Ed Mullinger 801-775-1750 mull@mbari.org	Layout: Jose Rosal	Size: Custom	CAGE Code: <Cage Code>	DWG NO: 1002716	Rev: 2.3
Friday, May 13, 2005	Scale:	Sheet:	1	of 2

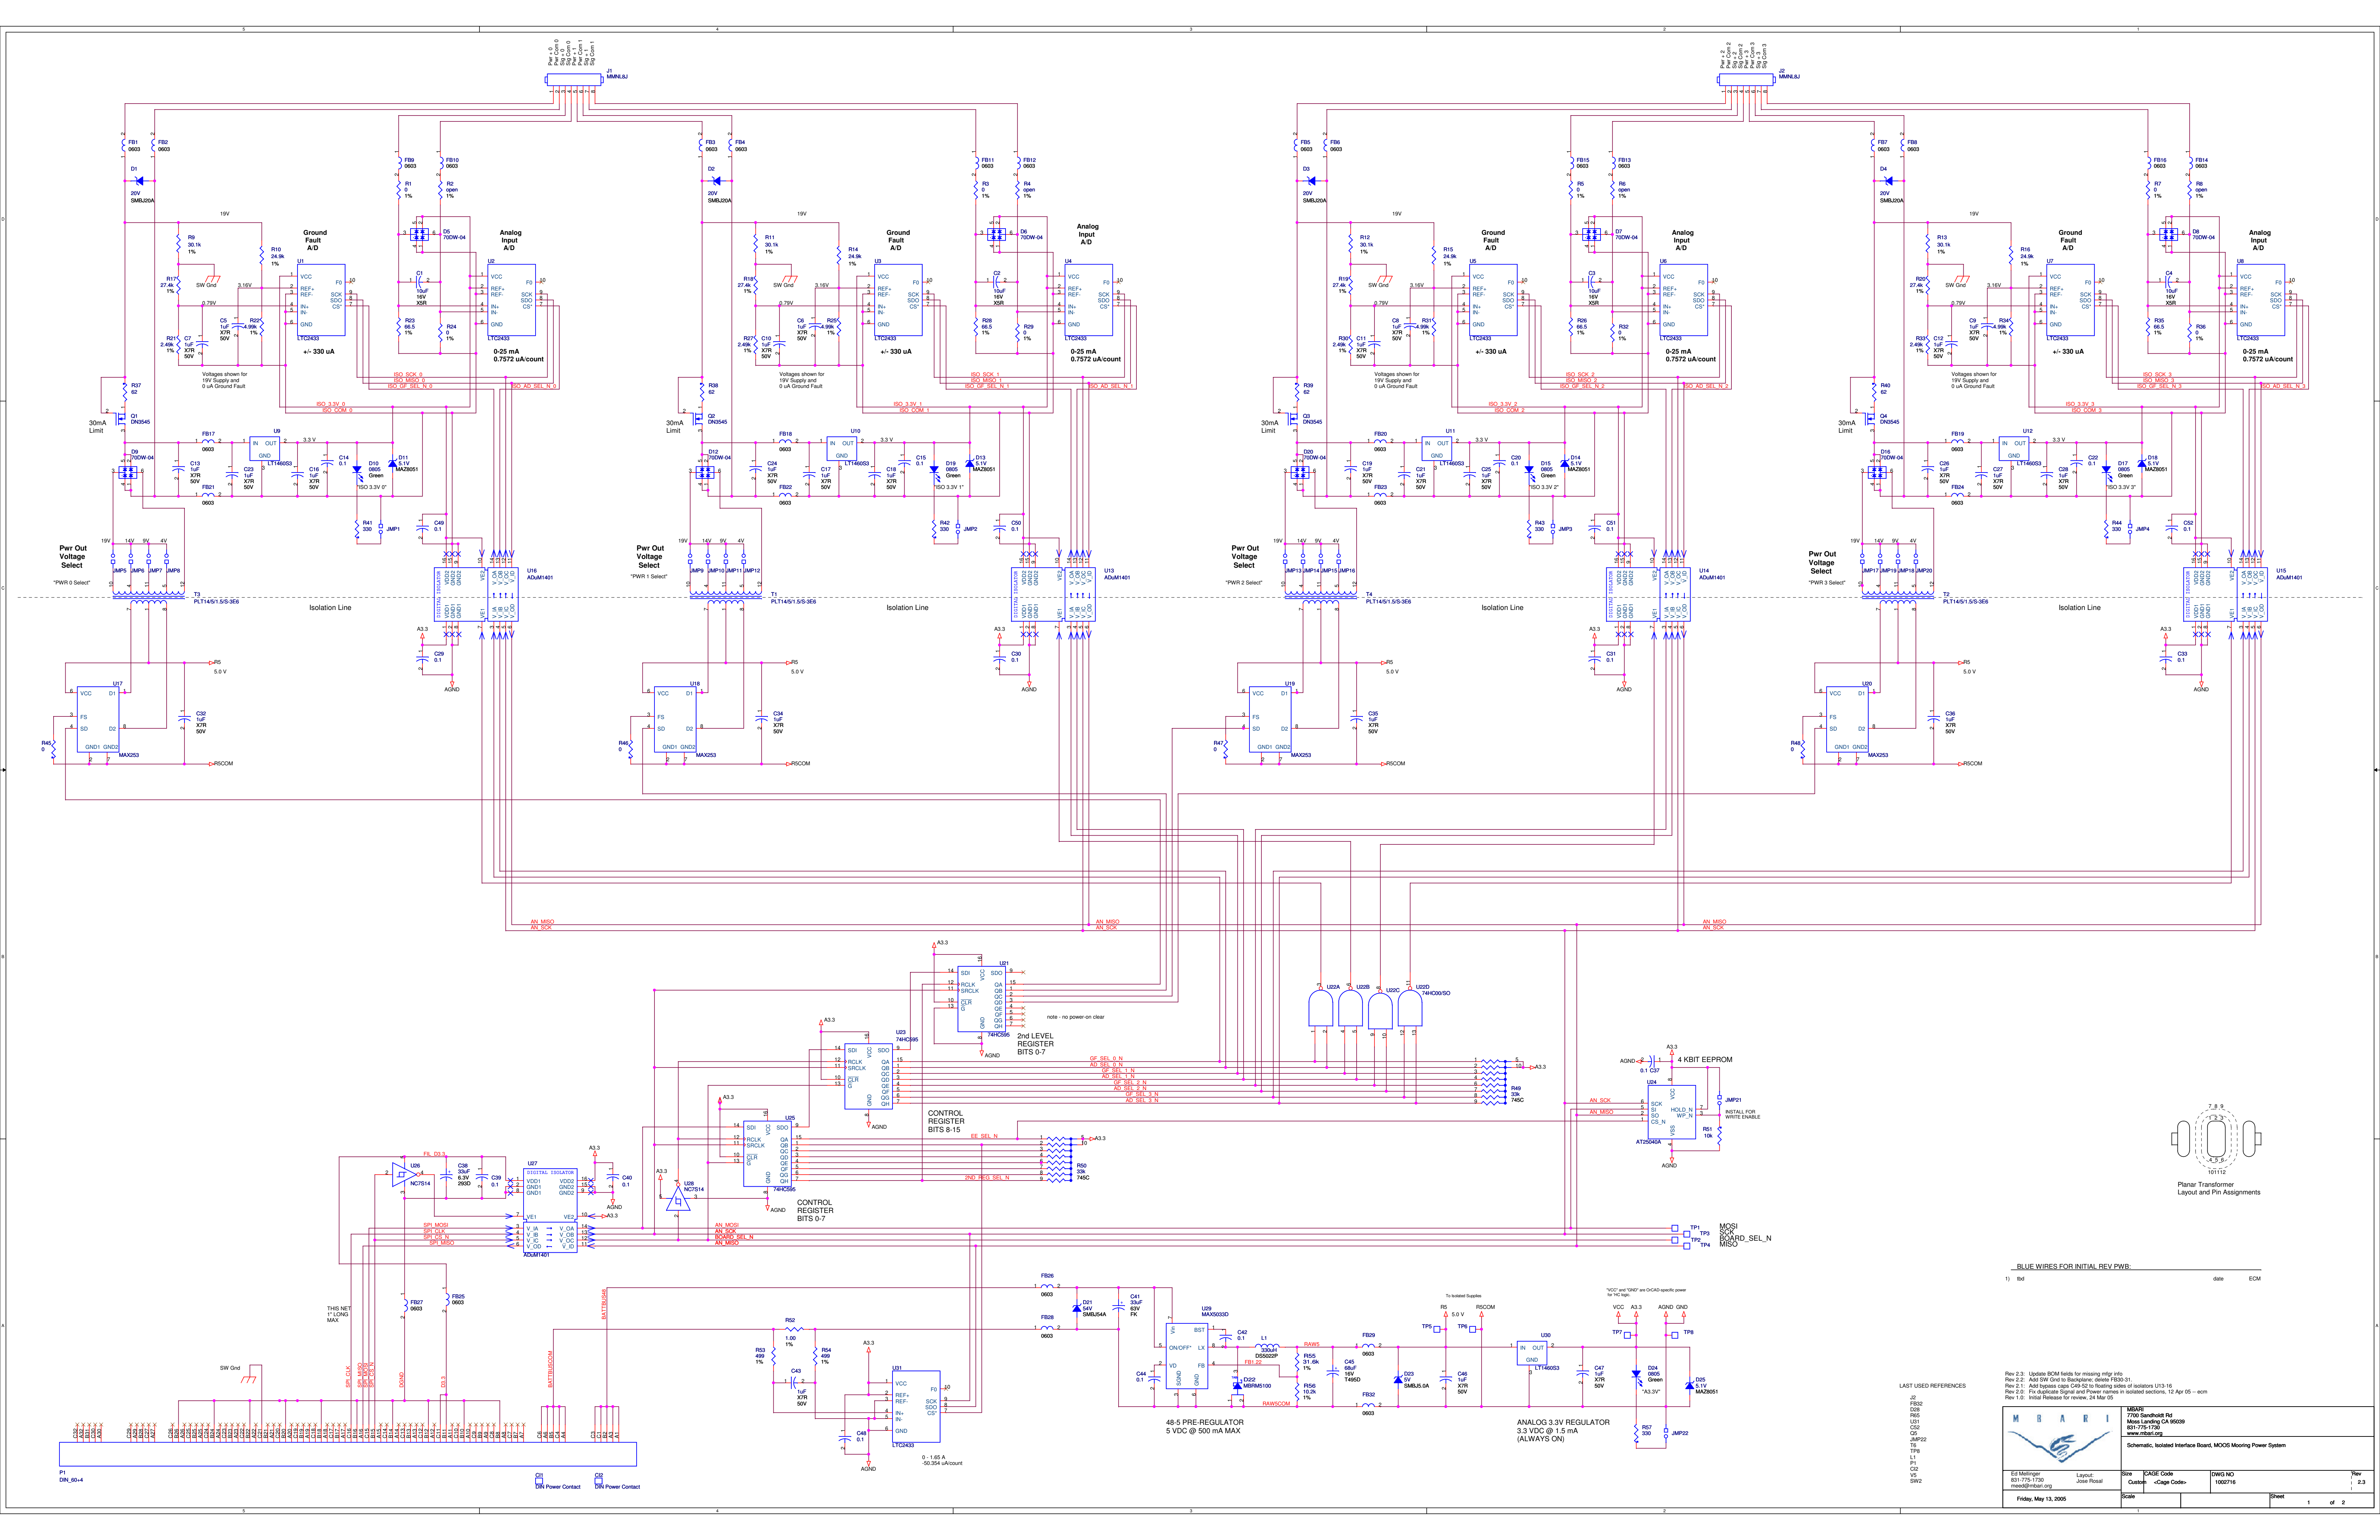
Rev 2.2: Update BOM fields for missing mfr info.
Rev 2.2: Add SW GND to Backplane; delete FB30-31.
Rev 2.1: Add bypass caps C48-52 to floating sides of isolators U13-15.
Rev 2.0: Fix duplicate Signal and Power names in isolated sections, 12 Apr 05 - ecm
Rev 1.0: Initial Release for review, 24 Mar 05
